ST. TAMMANY PARISH

Addendum No.: 2

Bid#: 24-35-2

Project Name: Diversified Water Well Pretreatment System

SHEET NO.
M-101
SHEET XX OF XX

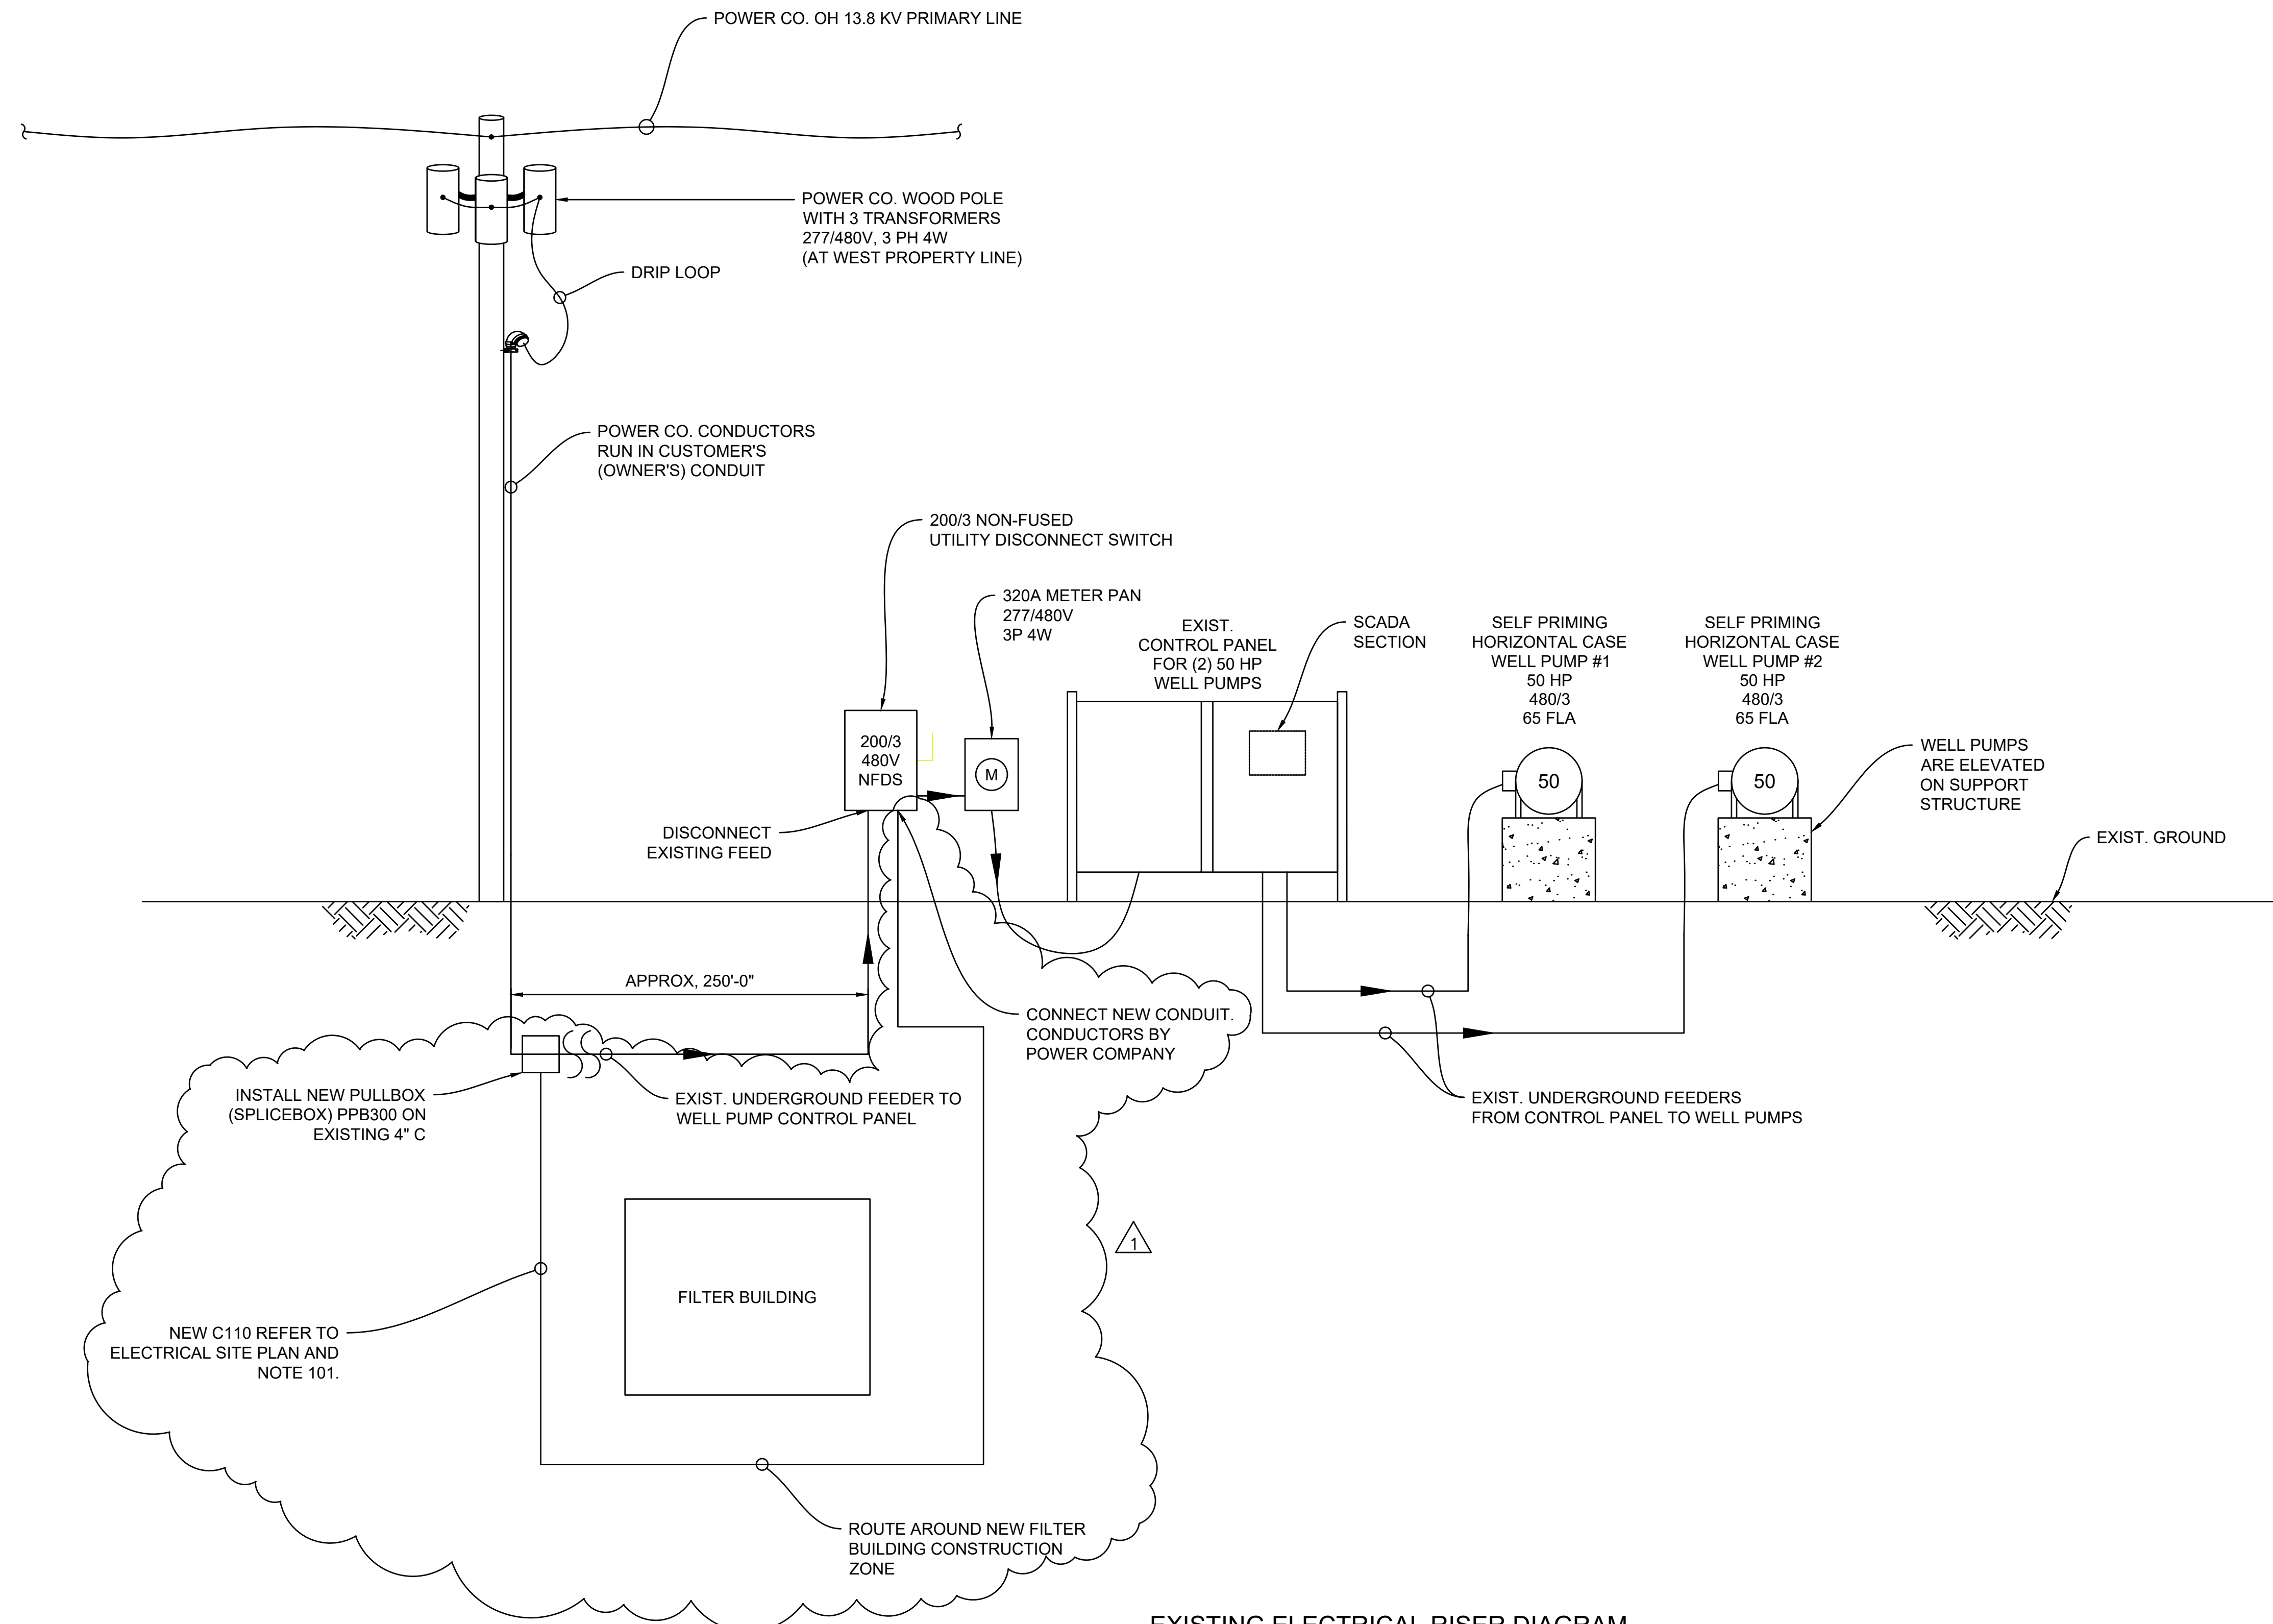
41. **Replace** Plan Sheet M-101 Mechanical Floor Plan with the attached revised Sheet M-101, showing the required installation of a backdraft gravity damper in the air duct line between the chemical storage room and office #1.

EXISTING ELECTRICAL RISER
DIAGRAM

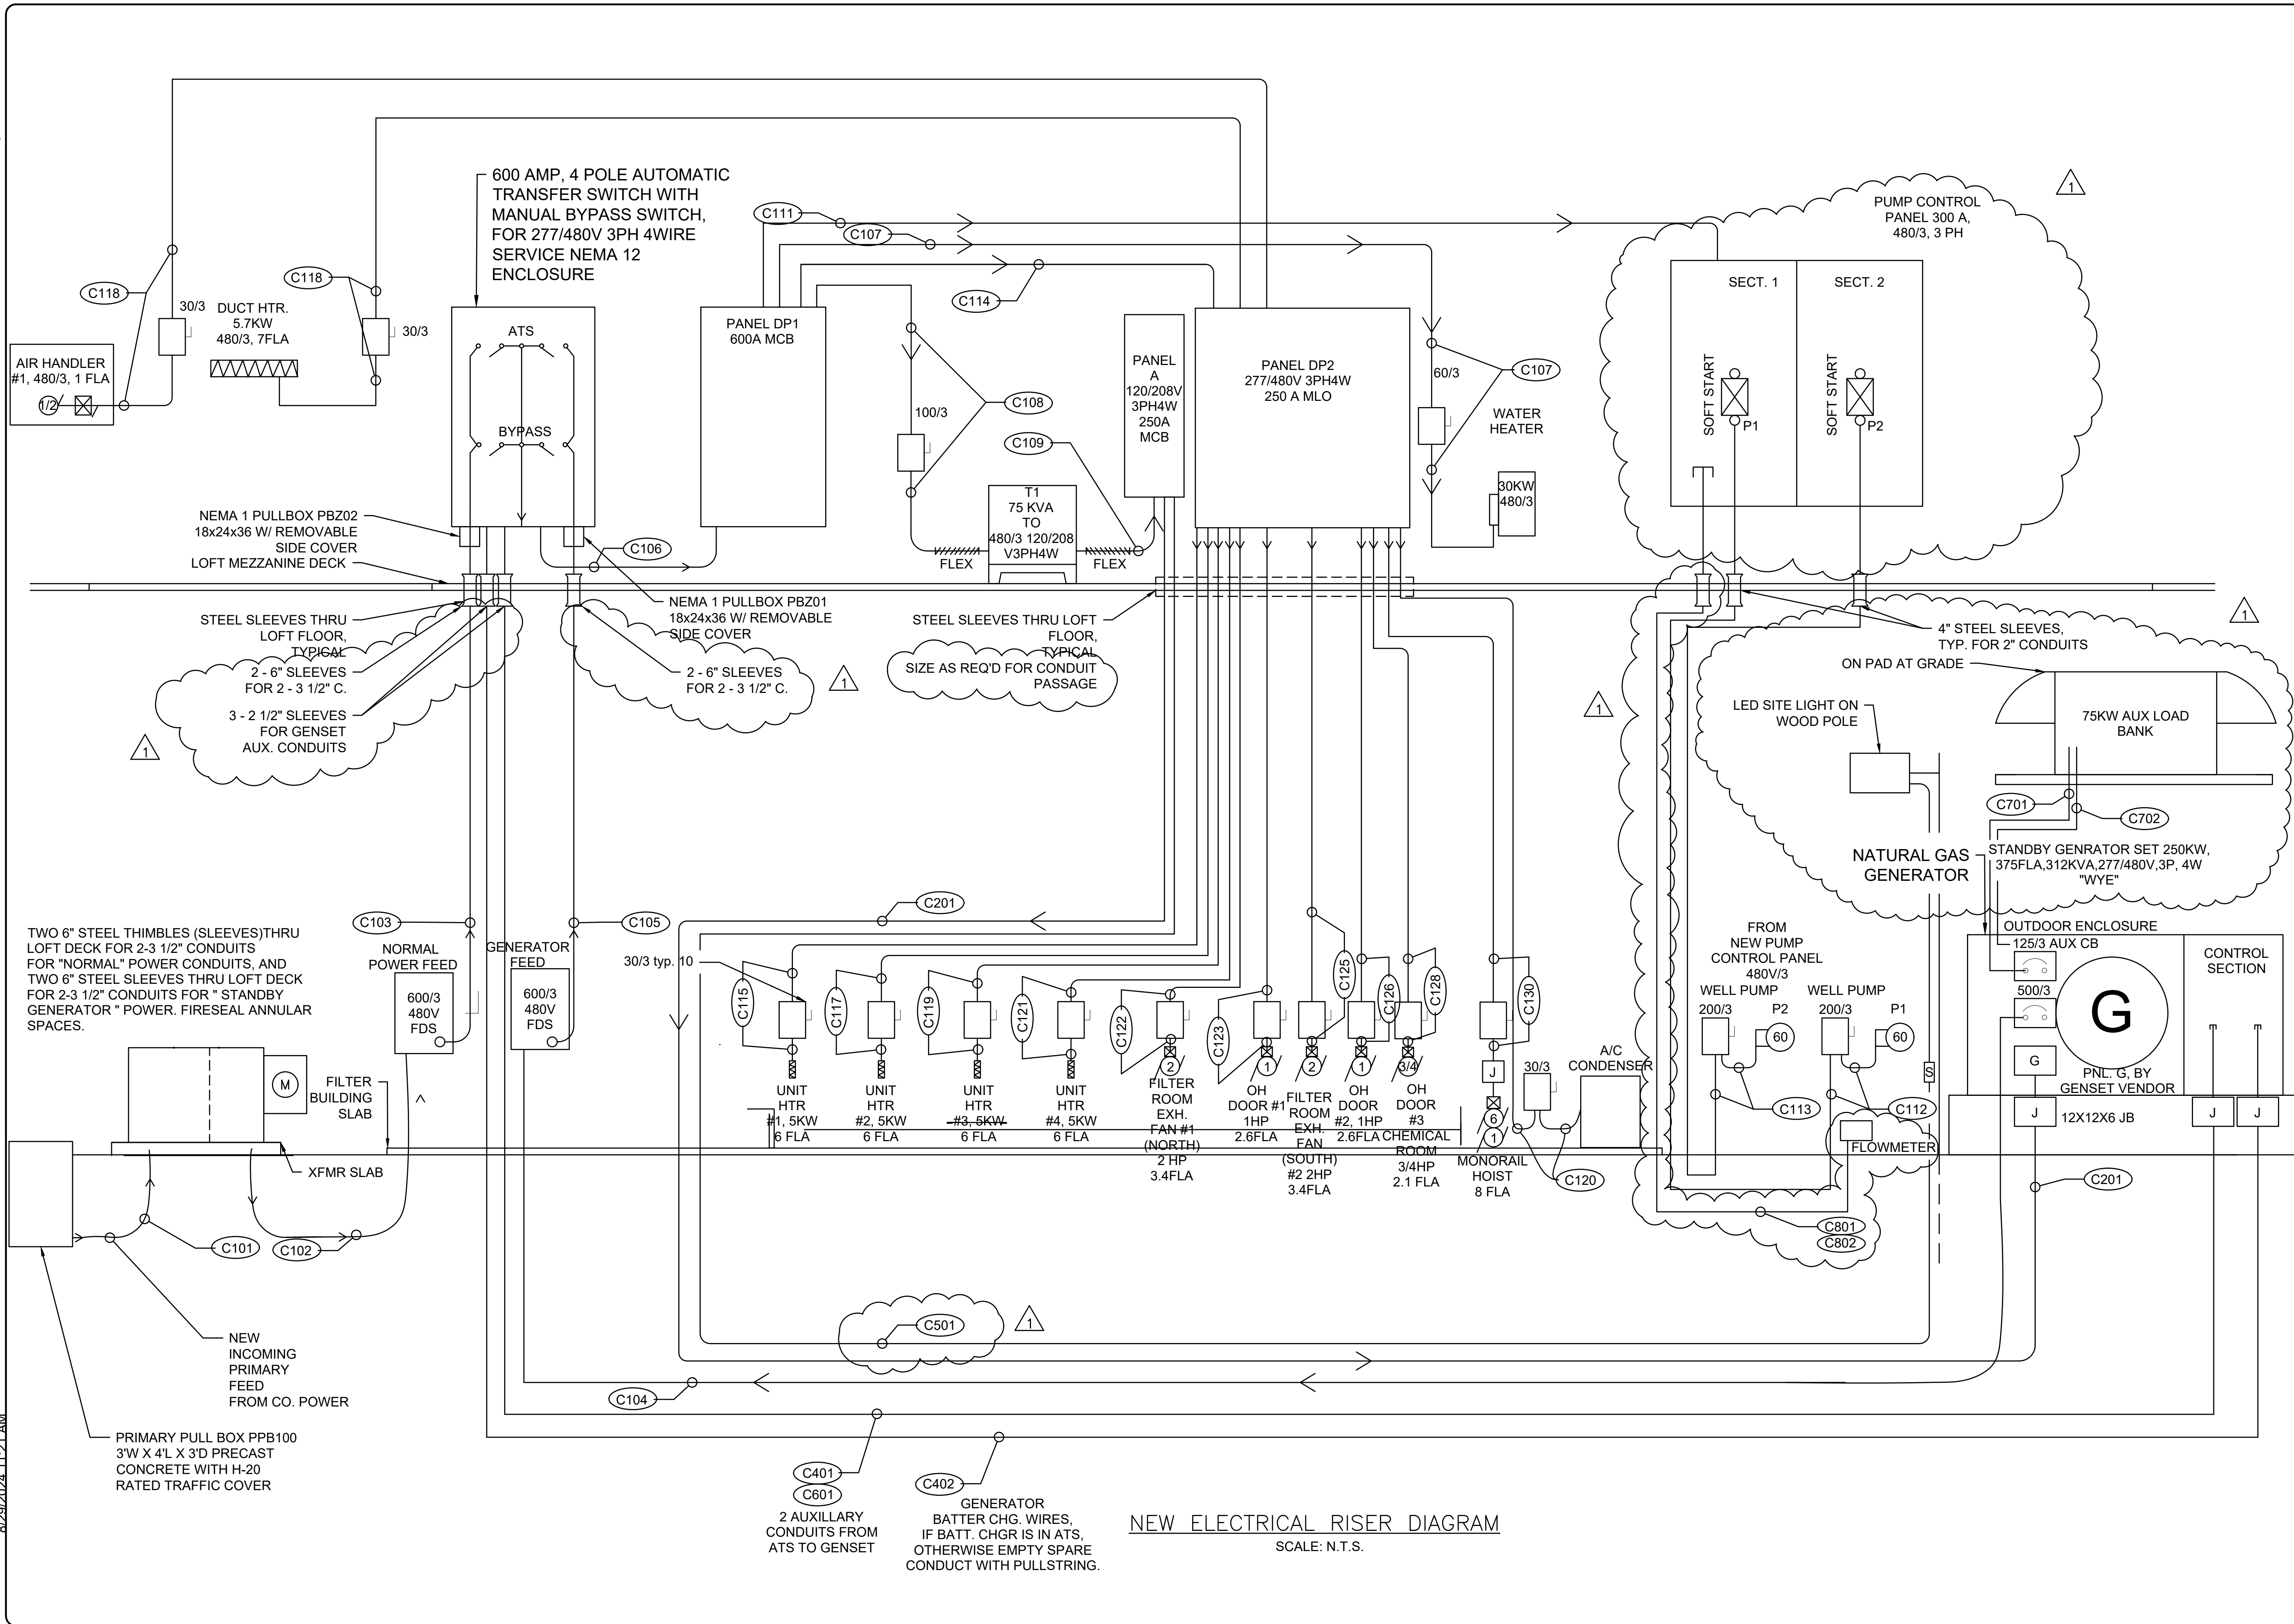
Question 7: Drawings E-003 and E-005 show existing Electrical One Line Drawing which appear to be the same just different views; is this service to remain active since there are no demolition of electrical equipment shown on any drawings?

Answer 7: Refer to the attached revised electrical drawings which show temporary electrical feeder to operate well pumps during construction of filter building.
